Subject: Comments on Recently Received Documents Pertaining to
 Seattle Tacoma International Airport Project
 Third Runway – Embankment Fill and West MSE Wall

GeoSyntec Consultants (GeoSyntec) has been retained on behalf of the Airport Communities Coalition to provide a technical review of investigation, analysis and design relating to construction of the embankment fill and West Mechanically Stabilized Earth (MSE) Wall elements of the proposed Third Runway Expansion Project at the Seattle Tacoma International Airport. GeoSyntec first commented on project documents in a letter dated 16 February 2001. This letter summarizes GeoSyntec's comments on documents relating to the project which were not available during the first review. The new documents reviewed are the following:

Document 1: *"Geotechnical Engineering Analyses and Recommendations – Third Runway Embankment – Seattle-Tacoma International Airport – SeaTac, Washington," Prepared for HNTB by Hart Crowser, December 4, 2000*

Table A-8 - Displacements Calculated using the Composite Strength Method

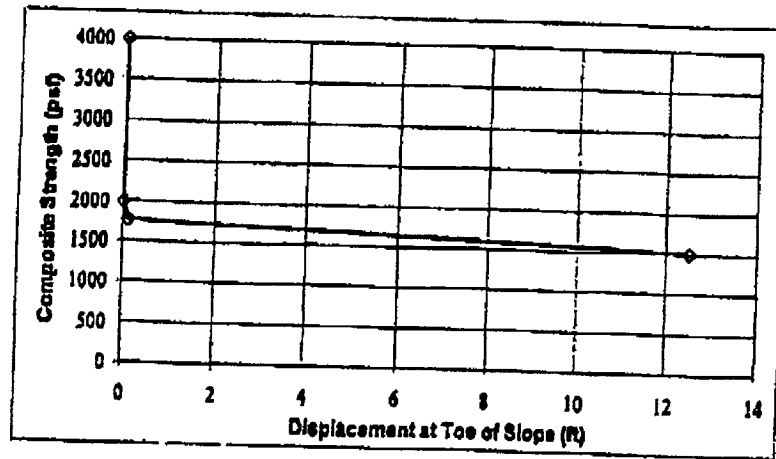
Comment 1D: Results of the FLAC deformation analysis are indicative of either numerical instability in the program or extreme sensitivity of the analysis to capacity and demand values rather than deformations that can be used as a basis for design.

Table A-8 of the report is presented here, showing results for FLAC deformation analyses using composite strengths:

Our interpretation of the results is that, as implemented, the FLAC analysis is encountering either numerical instabilities (i.e., significant mathematical errors are being generated as the program performs calculations) or physical instability. The evidence of this is the progression of deformation calculations. As the strength is decreased from 2000 psf to 1750 psf, an increase in deformation of 0.1 ft occurs at the toe of the slope. Then, an equivalent decrease in strength of 250 psf, from 1750 psf to 1500 psf, leads to an increase in deformation from 0.1 ft to 12.5 ft at the toe of the slope. The next decrease in strength by the same amount leads to an "unstable" output, which typically either means that the program could not compute an answer, or the answer it produced made no physical sense (e.g., it may have computed 100 ft of deformation).

Presumably, the same pattern of instability would be observed if the shear strength was held constant and the seismic load was gradually increased. This type of extreme sensitivity to seismic load or resistance is one of the driving factors behind the trend towards Performance Based Design (PBD), wherein seismic analysis can not look at a single design level, but must consider seismic performance over a spectrum of load
